# Land Use Committee Report

## City of Newton In City Council

**Tuesday, June 9, 2020**

**#26-20**      **Request to Rezone Approximately 4.4 acres to MU-3 to Create a Contiguous MU-3 Zone**  
MD 399 GROVE OWNER, LLC/RAMIREZ CONCORD, LLC/BH NORMANDY RIVERSIDE, LLC/MASSACHUSETTS BAY TRANSPORTATION AUTHORITY petition for a change of zone to Mixed Use 3/Transit Oriented District for portions of land located at 355 Grove Street (currently zoned BU-2) and 399 Grove Street (currently zoned BU-5), also identified as Section 42, Block 11, Lots 3, 4, and 4A, abutting the existing MU-3 Zone.

# Proposed Site Plan

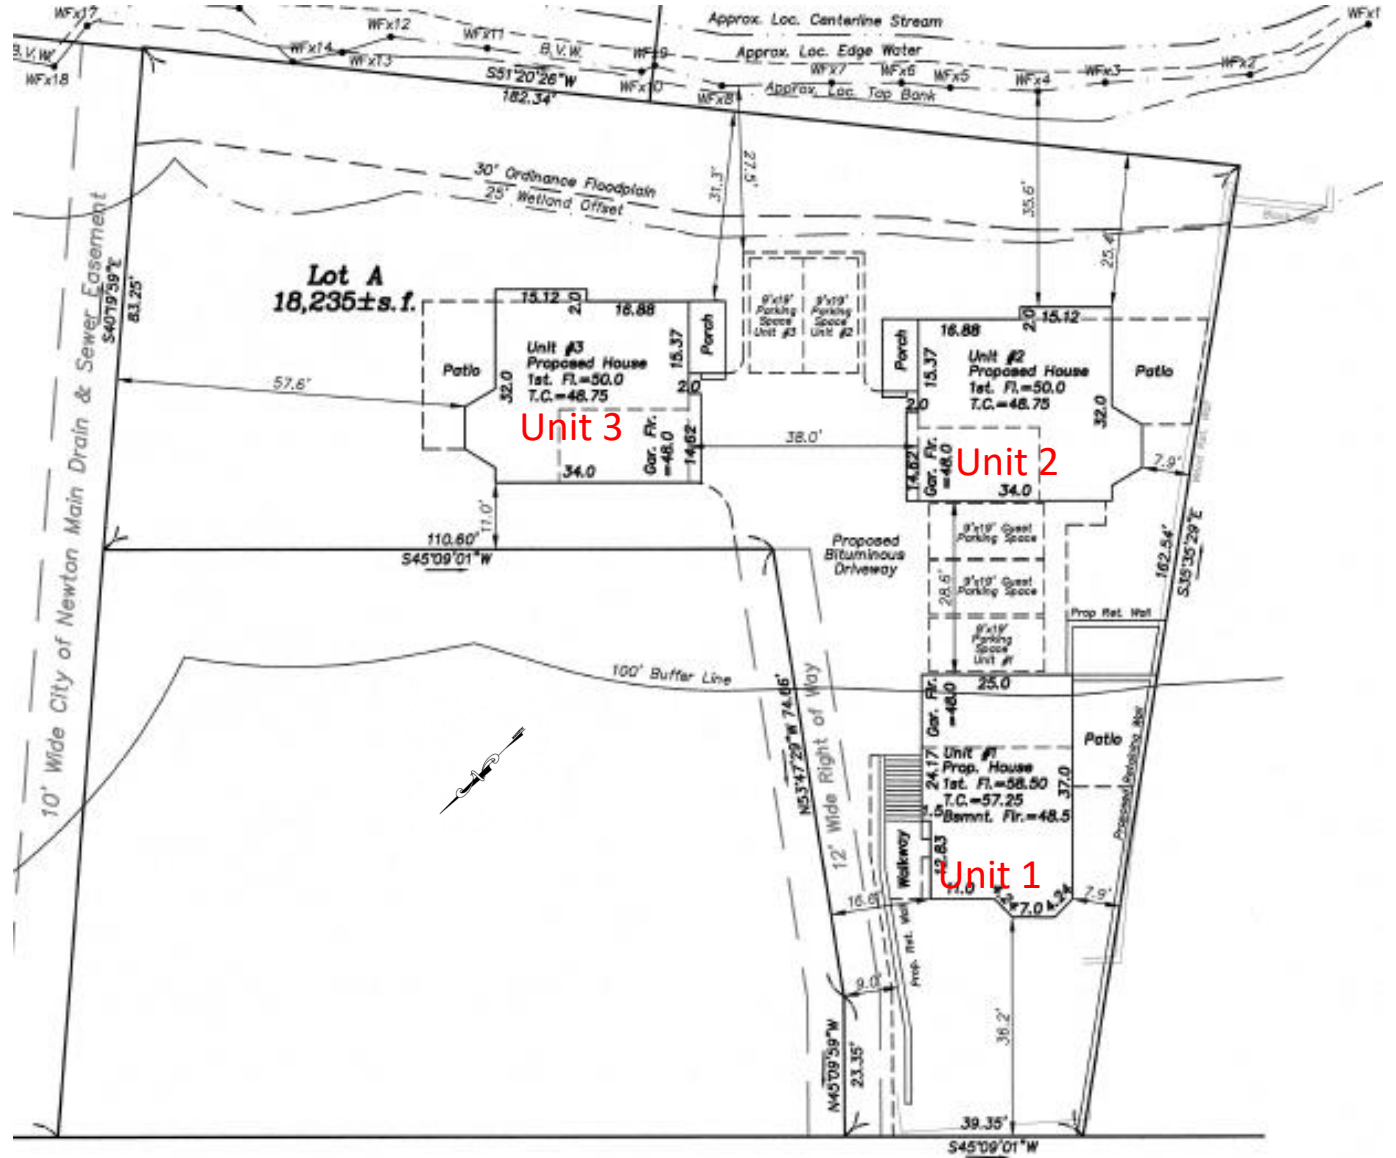
- The petitioner should address whether the patio space shown on the revised plan has been approved by the Conservation Commission.

- Consider either a greater distance between Units 1 & 2 or move Unit 2 so that it is not directly behind Unit 1 (for increased privacy)
- Remove or relocate parking to provide additional screening or demonstrate that privacy will be maintained

The Committee noted that the topography and layout of the site may make development challenging. It was suggested that plantings and enhanced privacy may be better than guest parking spaces. The Committee noted that the site is across from the Burr School, Pine Street is narrow and there is no on-street parking in the immediate area. Councilors expressed support for the number of parking spaces proposed and noted that having parking on the street is not a good idea, particularly for student safety. Chief Planner Neil Cronin confirmed that the Planning Department does not have a preference and the Committee was appreciative of the use of permeable pavers for the surface parking stalls. It was noted that Units 1 and 2 could be shifted slightly to accommodate some landscaping and increase the privacy for the residents.

Based on comparisons to rear lot subdivisions, Atty. Morris reiterated that the proposed development is not a rear lot subdivision and noted that the criteria for consideration is whether the proposed use is substantially more detrimental than the existing use is to the neighborhood. He suggested that the proposed development is appropriate, noting that the single residence 3 neighborhood consists primarily of old lots where dwellings can be 15' apart and the proposed dwelling units are 28.6' apart. Atty. Morris stated that a privacy buffer is possible between Units 1 & 2 but noted that it would require the removal of a guest parking space and installation of a 10' wide landscape buffer.

# Stormwater Management System Goals

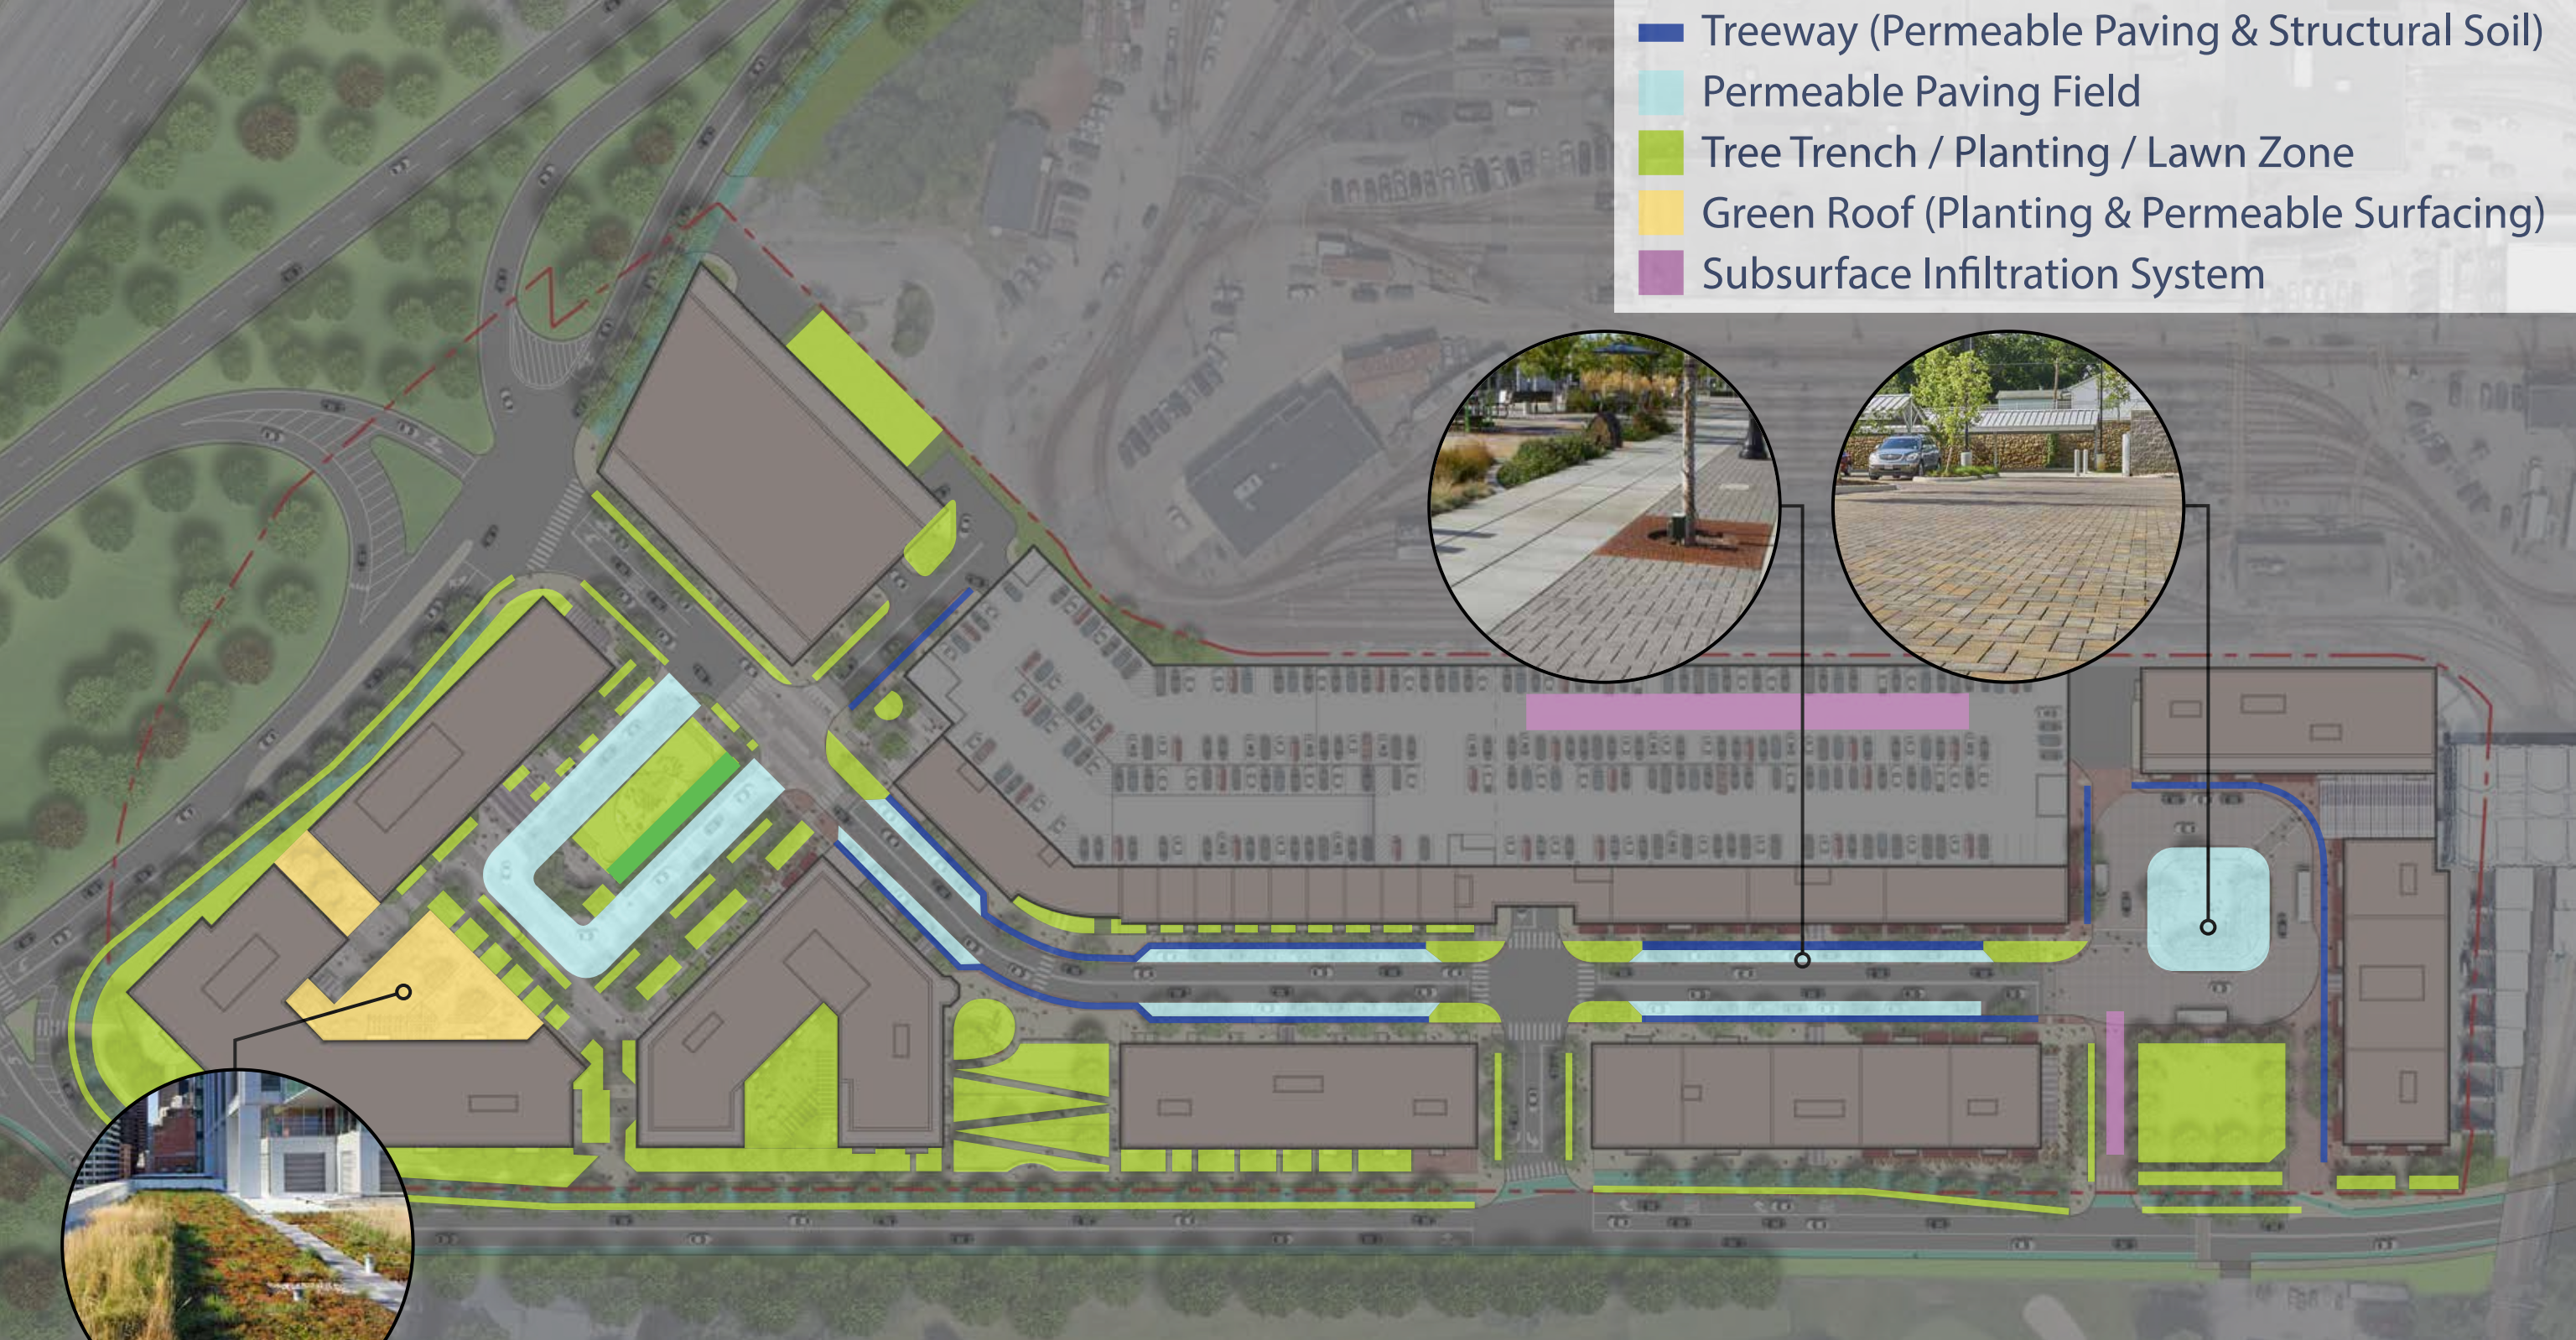
Q: On the stormwater contributions, there was some concern you wouldn't know the total suspended solids or other pollutants coming from the golf course or through the site. Could you measure this before and after to show the increase?

A: The existing drainage system isn't a single connection, that is exclusive to just the parking lot. Its several systems intermingled with the MTBA and connected in many places. We cannot take a single sample and understand the flow or water quality coming from the development parcel, we can only sample the end of the pipe. The most important thing to monitor is upflow of the pipe to signal if there are any issues with erosion control, etc. Upstream of the pipe is the Quinobequin pump station. It is important to know the capacity so flow can be diverted if necessary.
